**SUBJECT: Technical Specification Amendment Request dated August 23, 2000
License R-120
Docket No. 50-297**

UPDATED SAFETY ANALYSIS REPORT

PULSTAR REACTOR

AMENDMENT 14

Figure 6.1-1

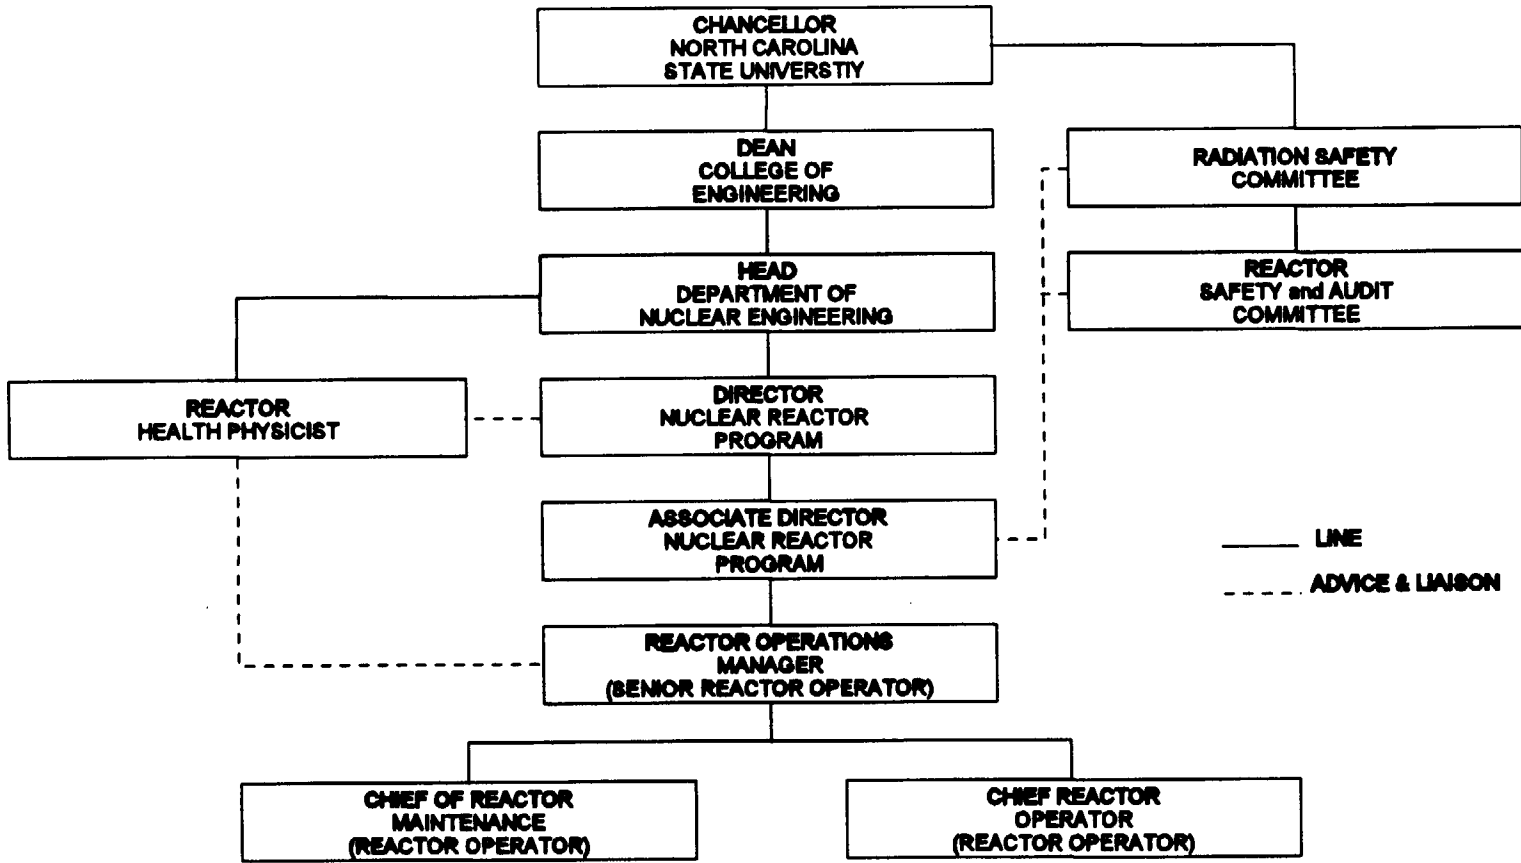
- Renaming of the "Radiation Protection Committee" to the "Radiation Safety Committee" and "Radiation Protection Division" to the "Radiation Safety Division" resulted in numerous changes to TS. No change was made regarding the function or responsibility of these groups. The name changes were approved by the then named Radiation Protection Committee as part of the revised University Radiation Safety Manual.

Affected TS: 3.7, 6.1.1, Figure 6.1-1, 6.2.1, 6.2.2, 6.2.3, 6.2.4, 6.4.1, 6.4.2, 6.5, 6.6, and 6.8
